IV. Remarks

Amendments to the Drawings

III. Amendments to the Drawings

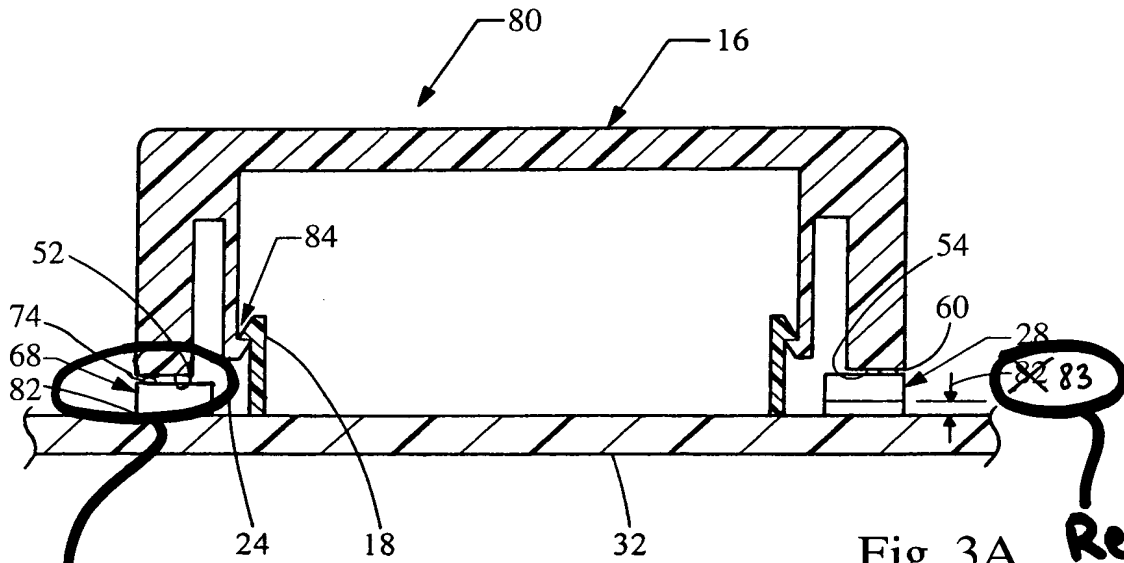
Sheet 3 has been amended to renumber the distance "82" on the left-hand side of Figure 3b as the distance "83". Additionally, the peak 52 in Figure 3b has been lowered to contact the projection 60, as disclosed in Paragraph [0033] of the original Application as filed.

Sheet 3 has also been amended to renumber the distance "82" on both sides of Figure 3c as the distance "83".

Fig. 3A

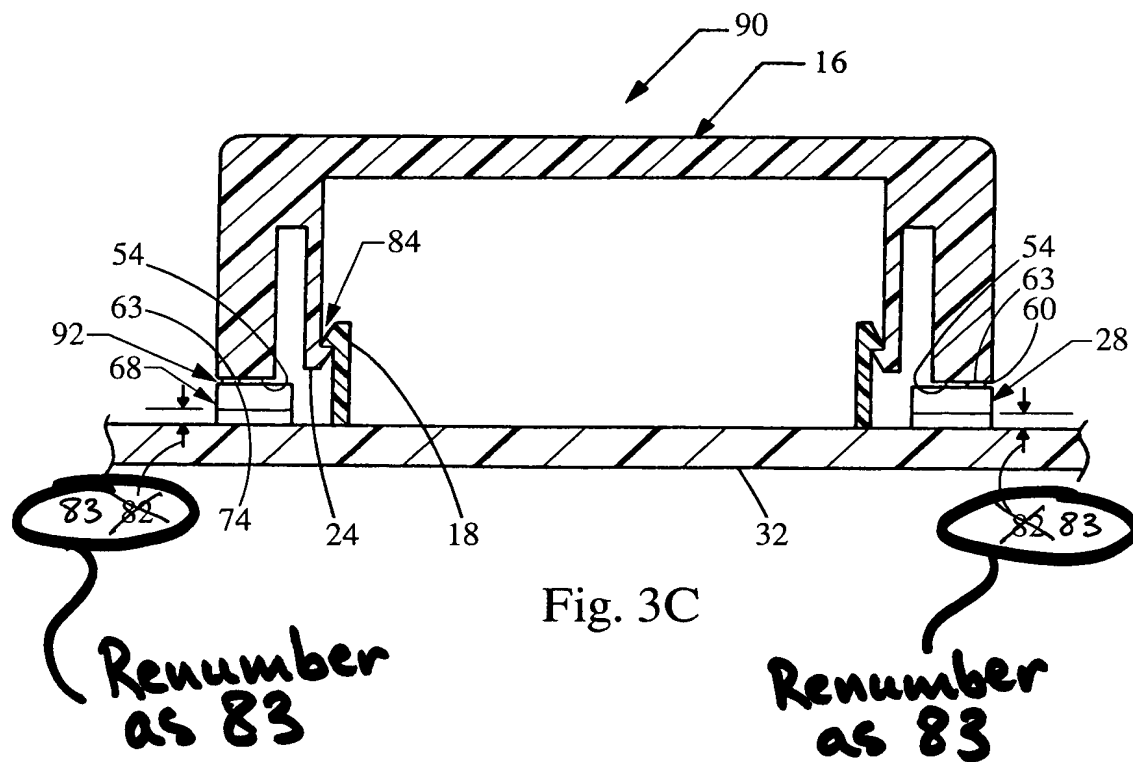
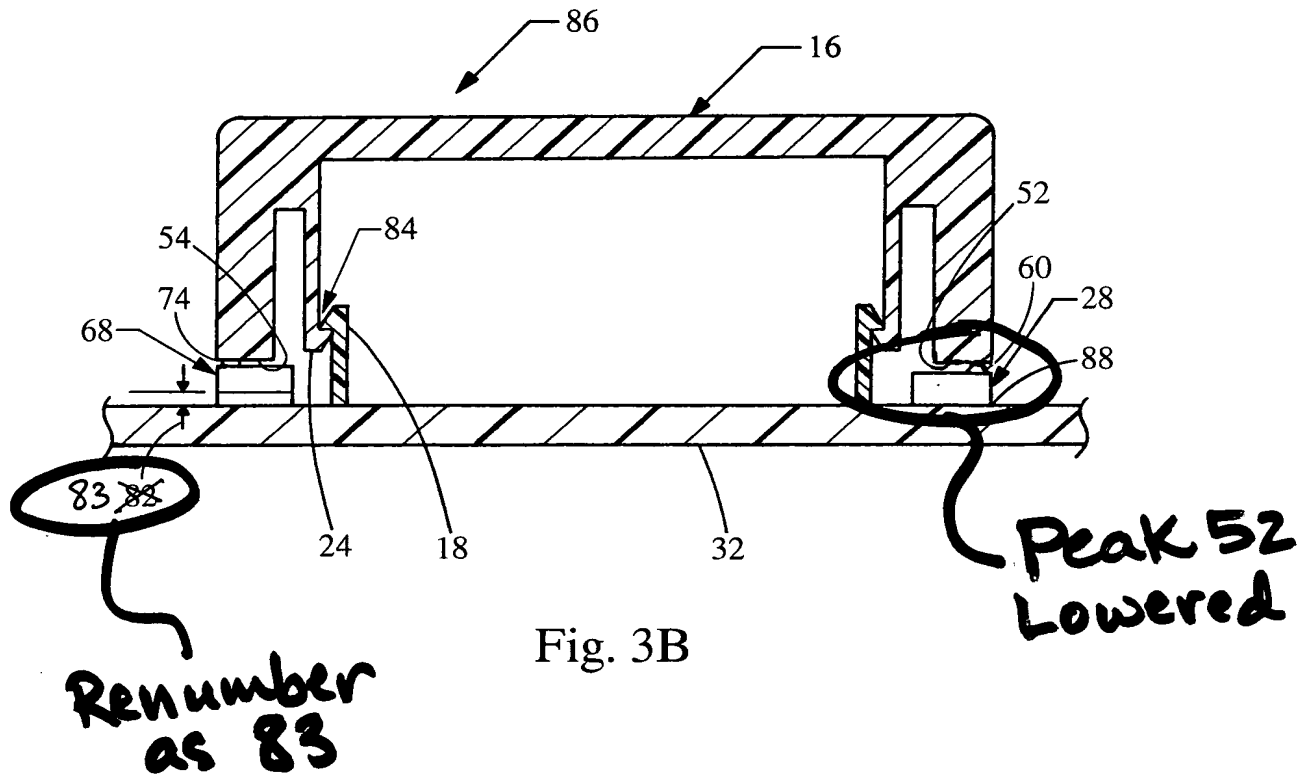
Sheet 2 has been amended to renumber the distance "82" on the right-hand side of Figure 3a as the distance "83". Additionally, the peak 52 in Figure 3a has been lowered to contact the projection 74, as disclosed in Paragraph [0032] of the original Application as filed.

Peak 52 Lowered

Renumber
as 83
